Note / Memo

To: Devinda Kumarasinghe, Oxfordshire County Council
From: Juliet James
Date: 09 February 2024
Copy: -
Our reference: PC5143-RHD-ZZ-XX-ME-R-0002
Classification: Project related
Checked by AF/AW

Subject: Parcel R, Kingsmere, Bicester (23/03073/HYBRID)

TITLE
Two-Way Operation Within Site

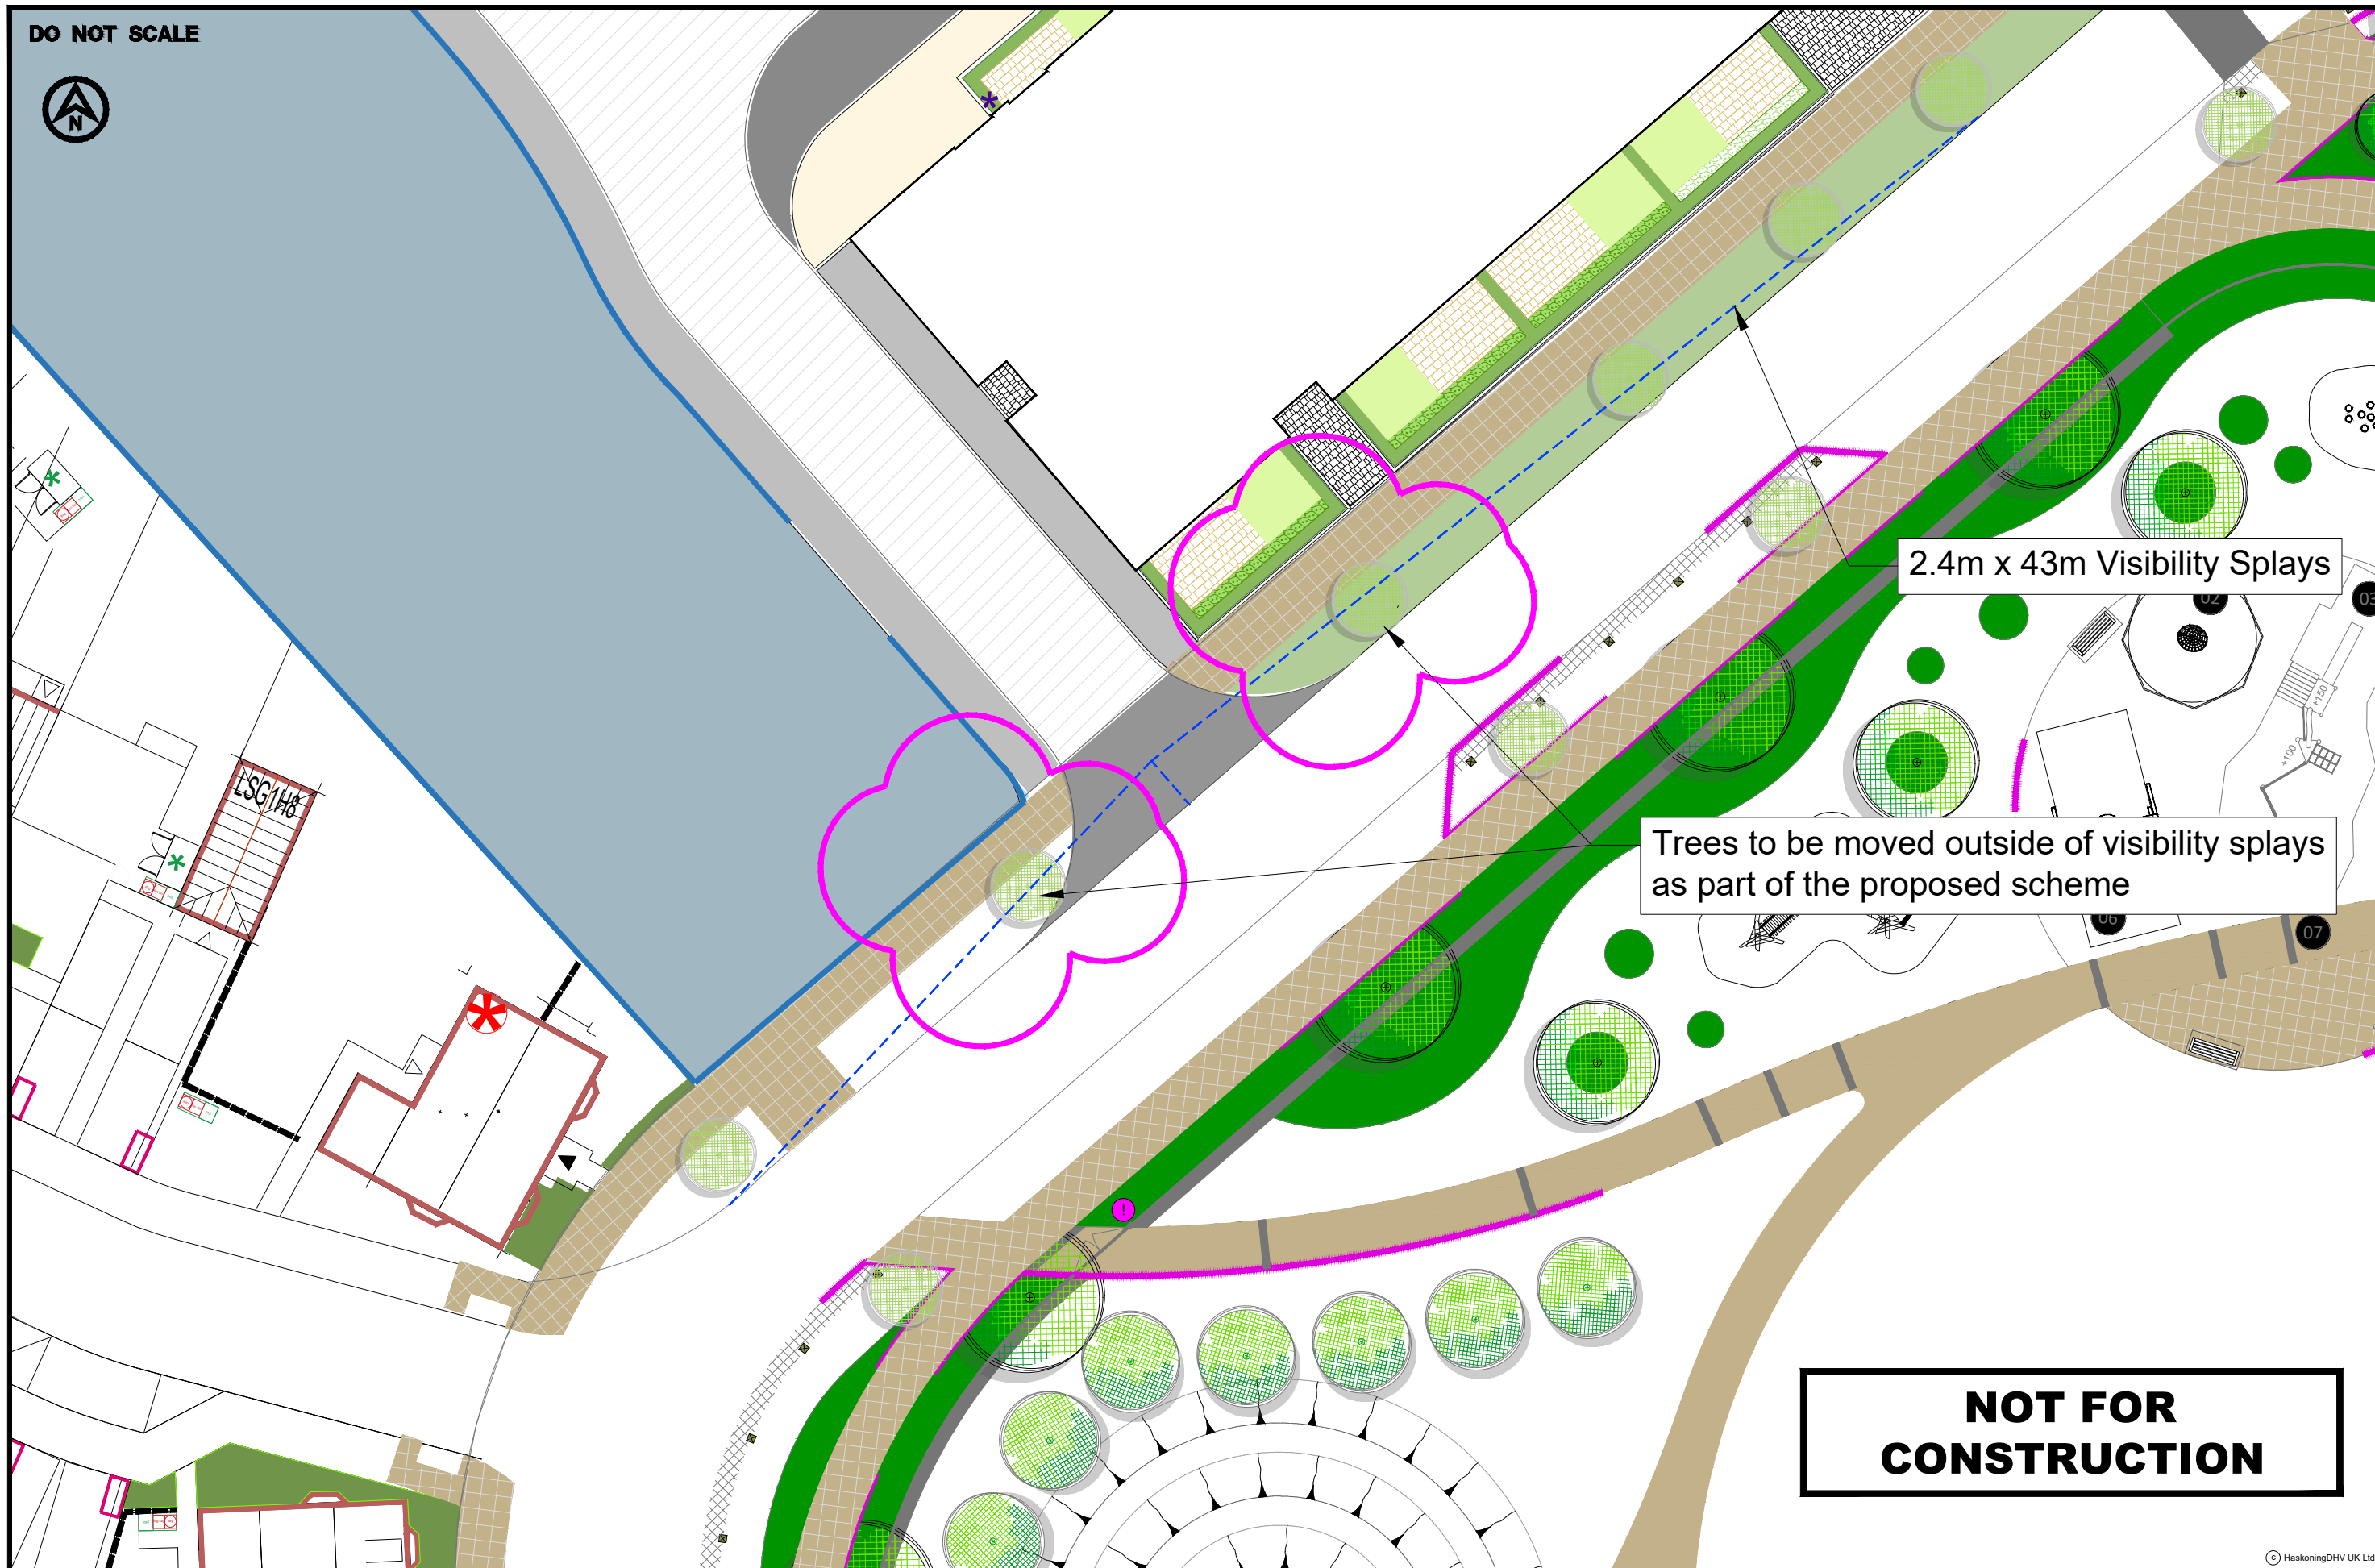
“The dimensioned site layout plan indicates some aisle widths of 4.63m near turning paths which is narrow for two-way vehicle movements. Safe two-way vehicle movement has not been demonstrated.”

- 3.2.1 An updated proposed Site Layout, and a dimensioned plan of the on-site vehicular circulation and parking areas, is included in **Annex B** which incorporates adjustments to provide additional carriageway width at both. Swept path analysis indicating two-way movements for a large car within the updated site layout is included in **Annex C**.
